Piper Aircraft Corporation
Vero Beach, Florida, U.S.A.

SERVICE No. 644D BULLETIN

Turbocharger Exhaust Coupling
Inspection/Replacement

Add PART III, Add Sketch "B",
Revise PART II Instructions,
Correct Part Number in Material
Required, and Revise Purpose.

SKETCH "A"

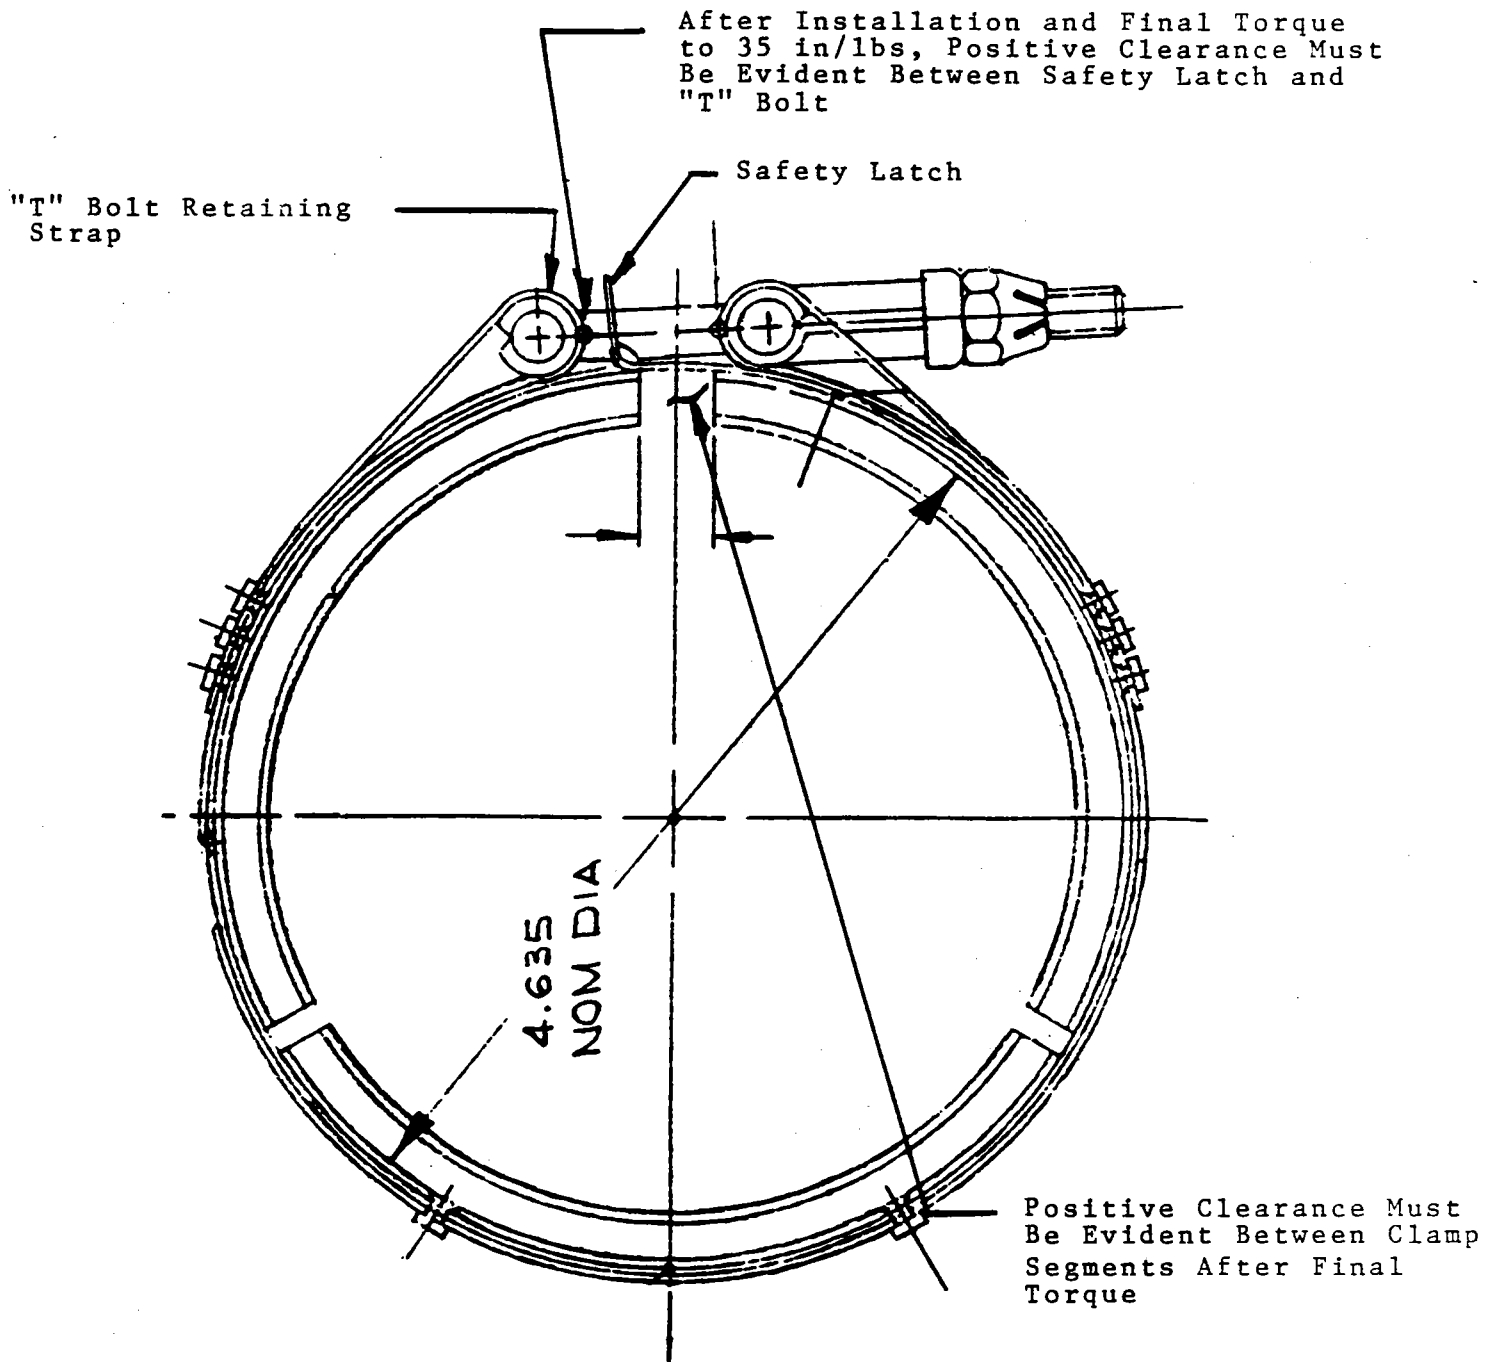
1. Within the next ten (10) hours of operation, determine type of turbocharger exhaust coupling installed:
 - a. If single-piece type, Piper Part Number 556-962 (PA-31/31-325) or 556-053 (PA-31-350), replacement is required prior to further flight.
 - B. If segmented type, Piper Part Number 555-511 (PA-31/31-325) or 555-366 (PA-31-350), proceed to Instruction 2 below, in accordance with Compliance Time, PART I.
2. Remove upper engine cowlings.
3. Remove turbocharger exhaust couplings. Inspect couplings for cracks, spreading of sides, and indication of exhaust pipe flanges bottoming in coupling. (Refer to Sketch "A" attached). Inspect coupling clamp bolt for bending, overstress and cracks. (Refer to Sketch "A").

7. Install coupling on exhaust flange and torque nut in accordance with Sketch "A" while tapping gently around the periphery with a soft mallet to distribute band tension.
8. Turbocharger to tailpipe coupling with one-thousand (1000) hours or more time in service must be replaced. (See MATERIAL REQUIRED, below).

Inspect Tailpipe And Turbocharger
Flanges For Proper Mating.

Inspect Turbocharger Flange For
Carbon Deposits, Cracks And Distortion.

Inspect Coupling Strap For
Cracks, Separation And Distortion.

Inspect Coupling V Bands For
Cracks, Separation From Strap
And Distortion.

Inspect Coupling Bolt For Bends,
Distortion, Cracks And Thread Damage.

Inspect Tailpipe Flange For Carbon
Deposits, Cracks And Distortion.

Torque The Coupling Nut In Accordance With This Chart

Model	Clamp Part Number	Torque
PA-31-350	555 366 (MVT68049-450M)	45-55 in. lbs.
PA-31/PA-31-325	555 511 (MVT69861-377M)	40-50 in. lbs.
